Access Compliance Report

Public Rights-of-Way

Intersection ID: 11660	Main Street: E_20TH_ST	Cross Street: HARRILL_ST	Location: E
ADA ID: C22753EA87A7	Ramp Type: PerpDiag	Initial Pass/Fail: Fail	Overall Compliance: No
		Severity Score: 30

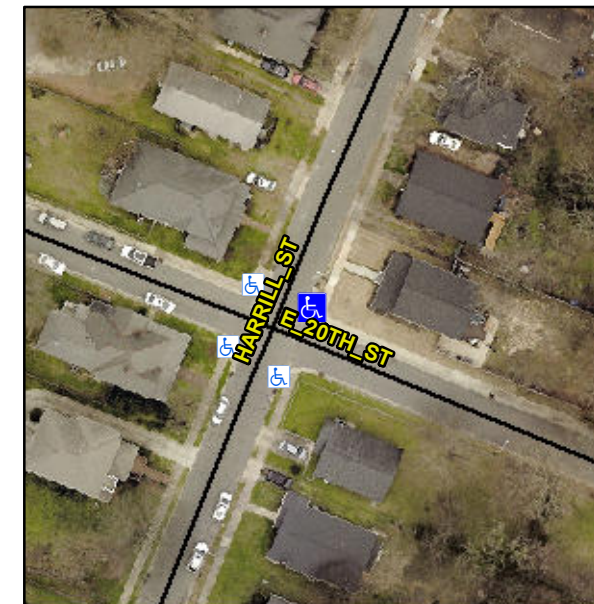
Not Found, R304.5.1, R304.2.2

Compliance	Description	Data	Compliance	Description	Data
N/A	Ramp Length (in)	54.5	No	Ramp Slope (%)	9.5
No	Ramp Width (in)	32.0	Yes	Ramp XSlope (%)	0.6
N/A	Flare Type LT	N/A	N/A	Flare Type RT	N/A
N/A	Flare Slope LT (%)	N/A	N/A	Flare Slope RT (%)	N/A
N/A	Flare Traversable LT?	N/A	N/A	Flare Traversable RT?	N/A
N/A	Landing Length (in)	N/A	N/A	DWS Provided?	N/A
N/A	Landing Width (in)	N/A	N/A	DWS Contrast?	N/A
N/A	Landing Slope (%)	N/A	N/A	DWS Length (in)	N/A
N/A	Landing X Slope (%)	N/A	N/A	DWS Full Width?	N/A
N/A	Landing Curb? (Y/N)	N/A	N/A	DWS Offset (in)	N/A
N/A	Shared Landing?	N/A			
N/A	Gutter Ponding?	N/A	N/A	Gutter Slope (%)	N/A
N/A	Gutter Lip Ht (in)	N/A	N/A	Gutter X Slope (%)	N/A
N/A	Painted X Walk1?	No	N/A	Painted X Walk2?	No
	X Walk 1 Direction	To NW		X Walk 2 Direction	To SW
N/A	X Walk 1 Width (in)	N/A	N/A	X Walk 2 Width (in)	N/A
	X Walk 1 Slope (%)	0.7		X Walk 2 Slope (%)	3.7
	X Walk 1 X Slope (%)	4.2		X Walk 2 X Slope (%)	2.8

Remove & Replace Curb Ramp With Two New Directional Ramps or Equivalent.
